## ORIGINATION FORM

### Proposed Revisions to a Standard Plans Index

Index Number: 455-160  
Sheet Number (s): 1  
Index Title: 60" Prestressed CFRP & SS Concrete  
Cylinder Pile

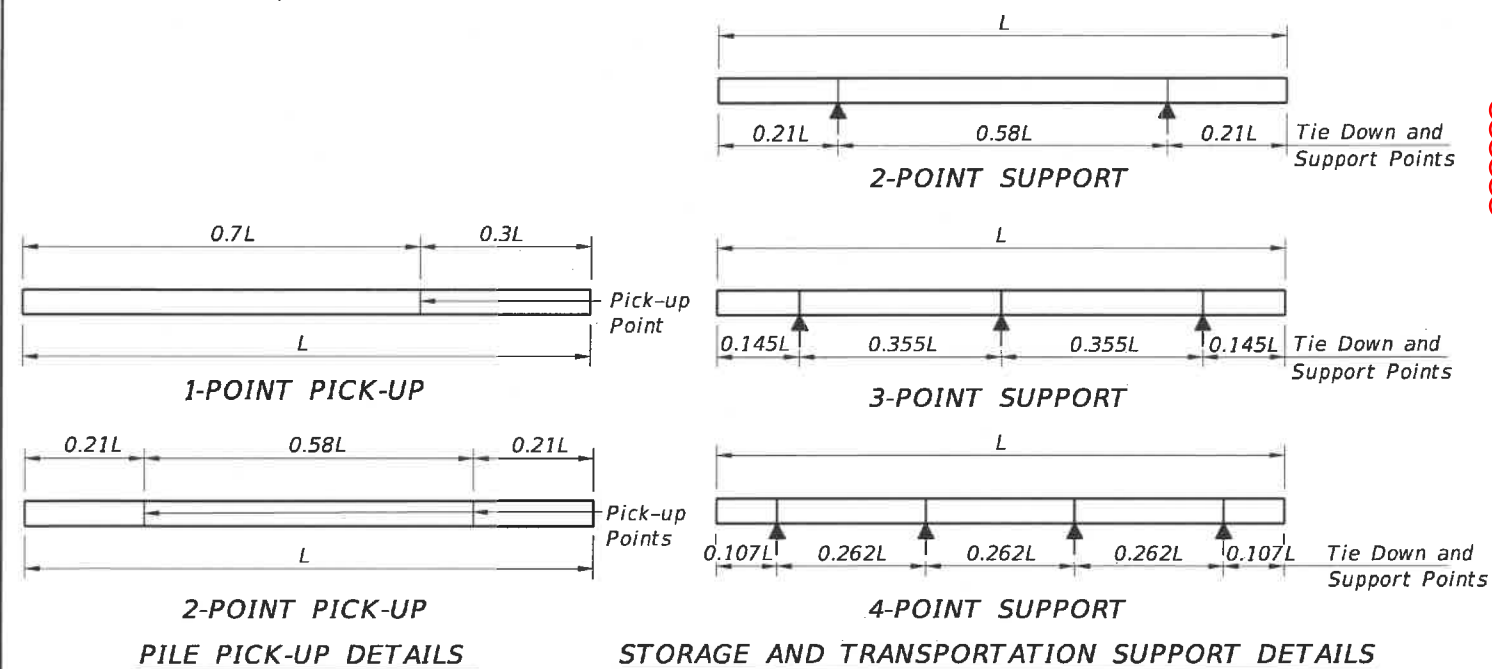
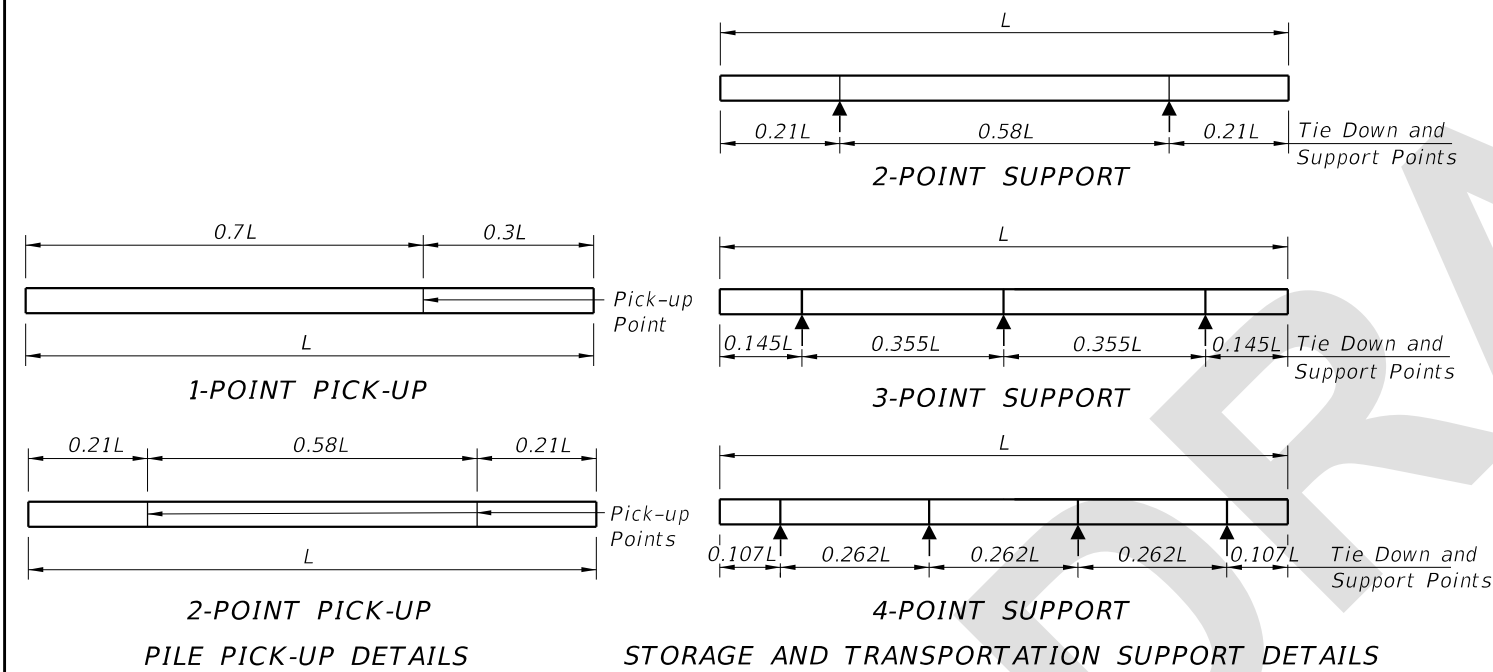
Changed Class V (Special) concrete to Class V.

1. Work this Index with the Pile Data Table in the Structures Plans.
2. Concrete:
  - A. Piles: Class V
  - B. Splice Collar: Class IV
  - C. See "GENERAL NOTES" in the Structures Plans for locations where the use of Highly Reactive Pozzolans is required.
